Project: Graff Residence
3 Middle Patent Road
Tax ID: 95.03-1-52

Please see our responses to the RPRC Determination Letter, dated 9/22/20 for the Graff Residence.

PRELIMINARY SITE PLAN
FOR
THE GRAFF RESIDENCE
ARMONK, NY

TITLE:
STORMWATER MITIGATION PLAN

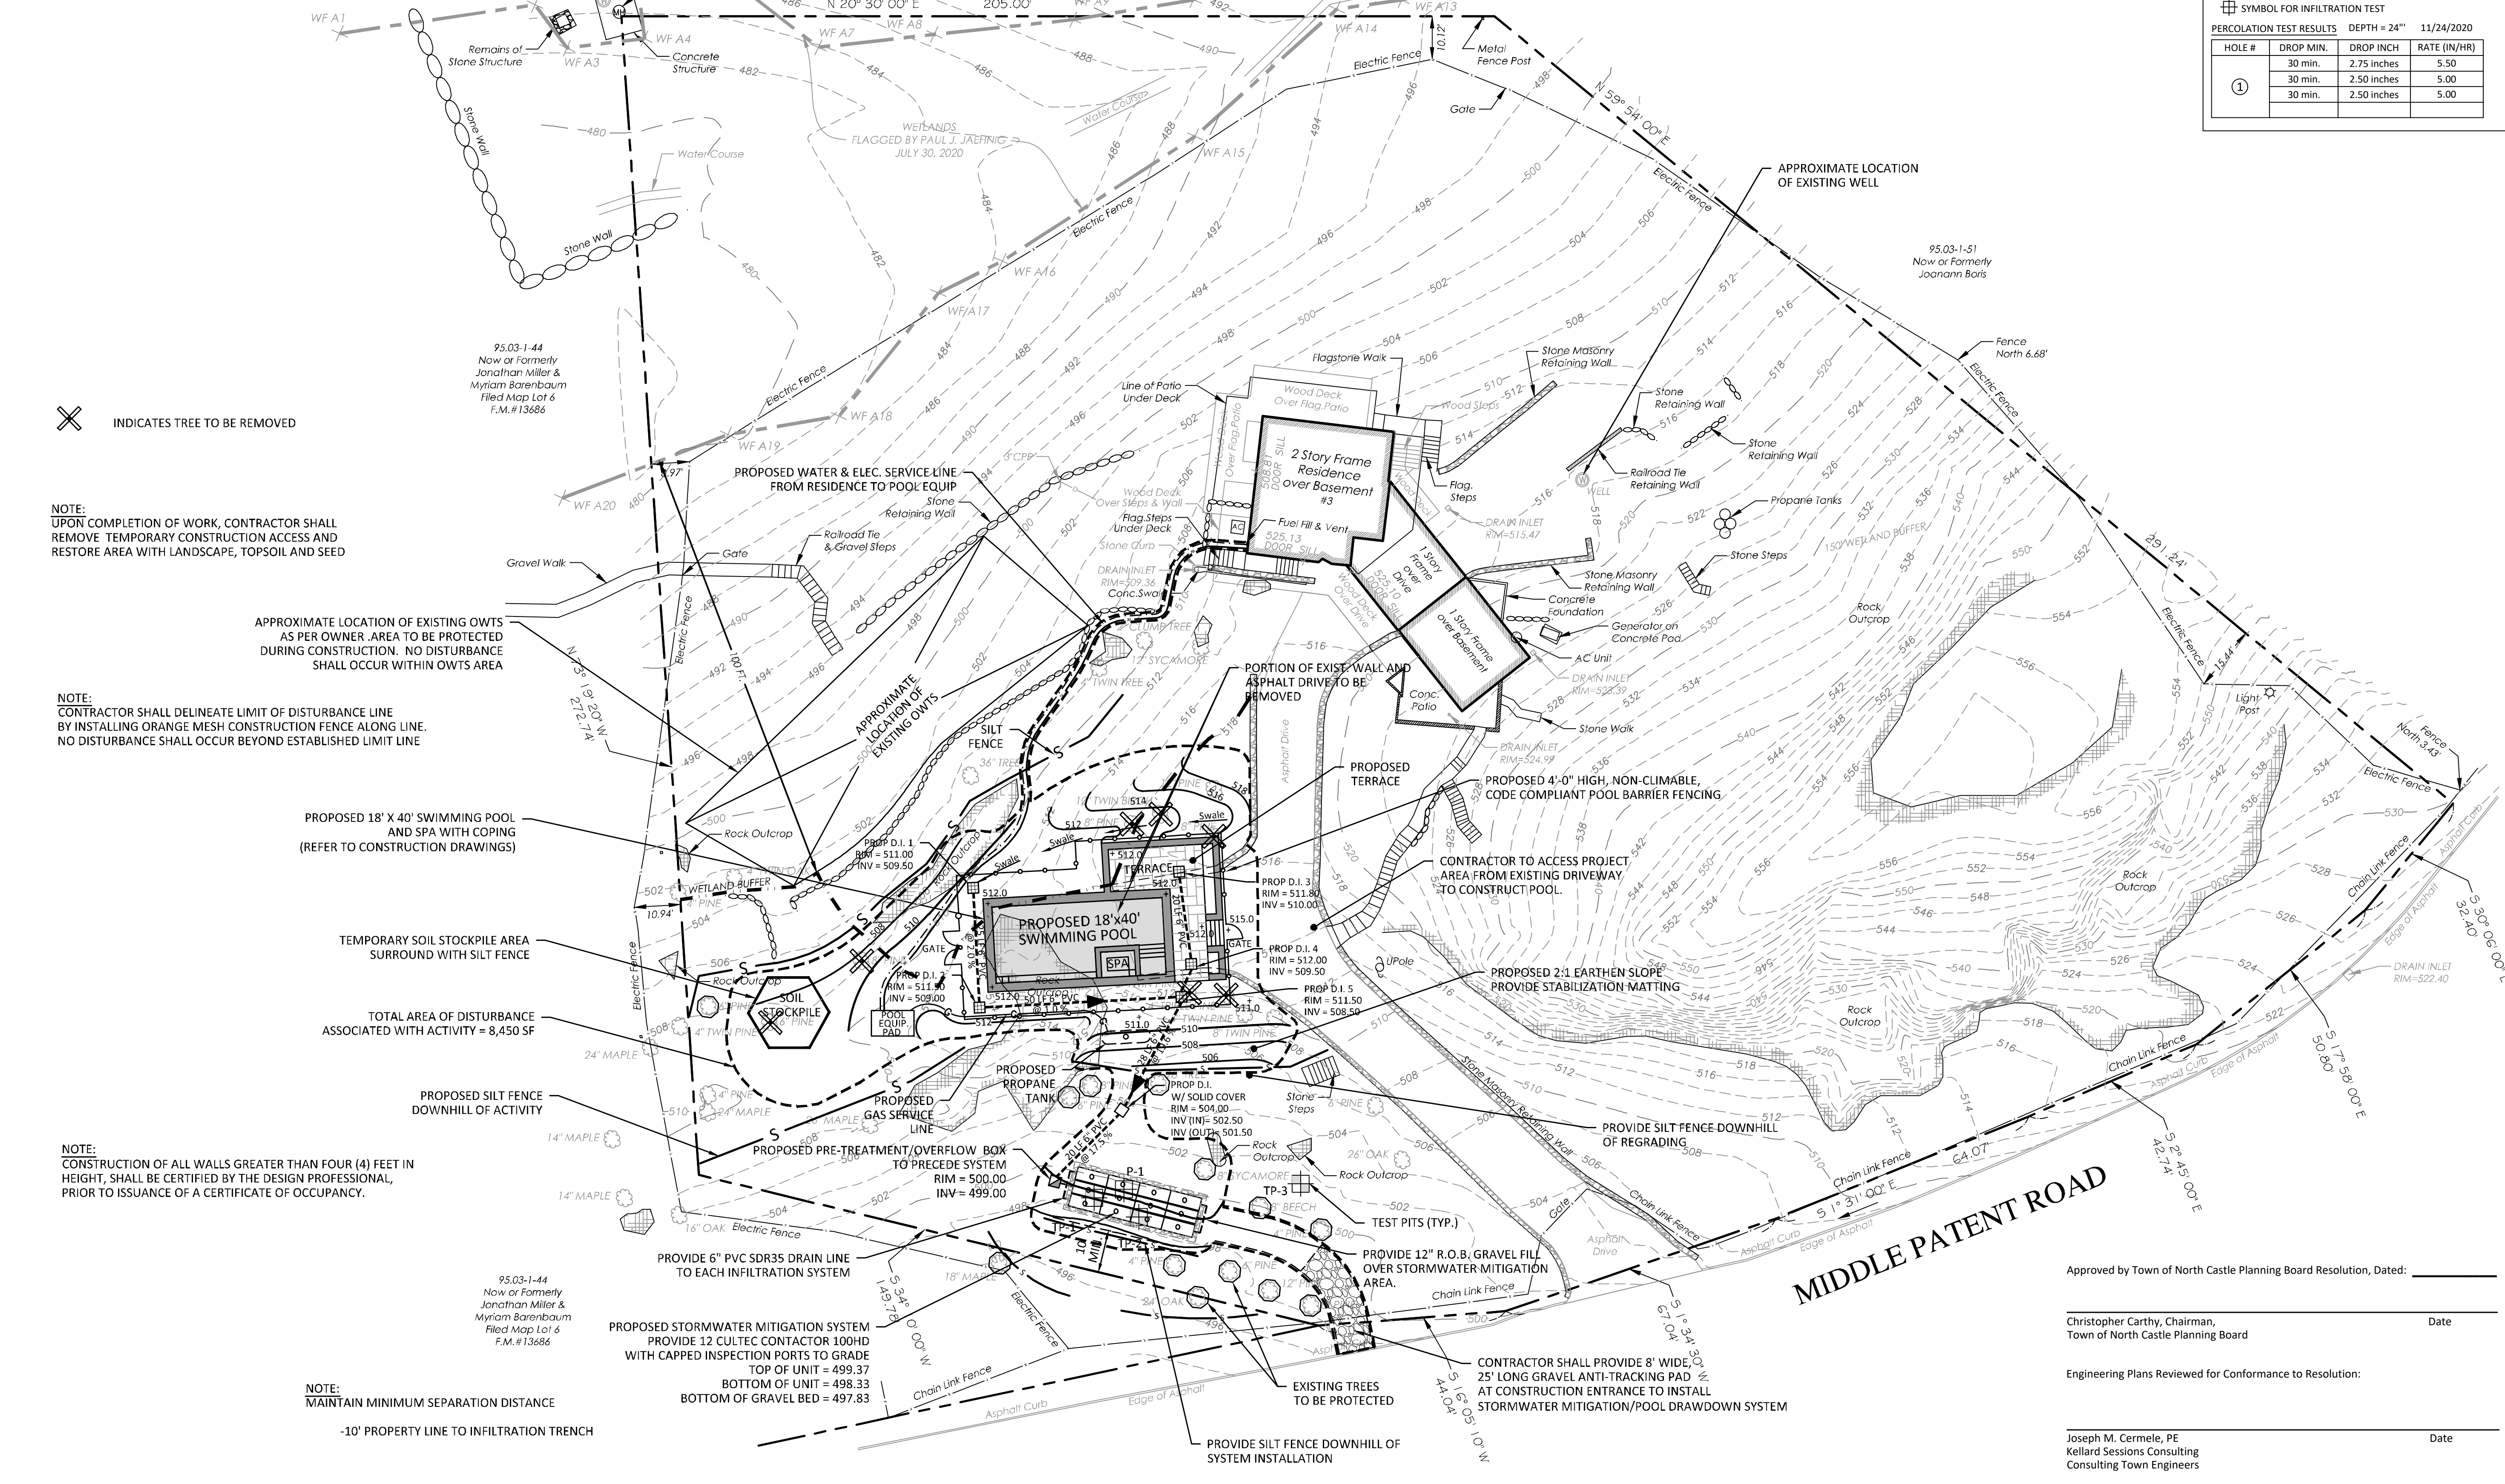
14. The Stormwater Mitigation Plan illustrates the connection between the pool equipment and the drawdown mitigation.
15. Rims, inverts, size and material for all drainage facilities are shown on the Stormwater Mitigation Plan and associated Details sheet.

16. Erosion control measures are shown on the Stormwater Mitigation Plan.
17. The limits of disturbance are shown on the proposed plans. A note has been added to the Site Plan that states, "The limit of disturbance shall be staked in the field prior to construction."
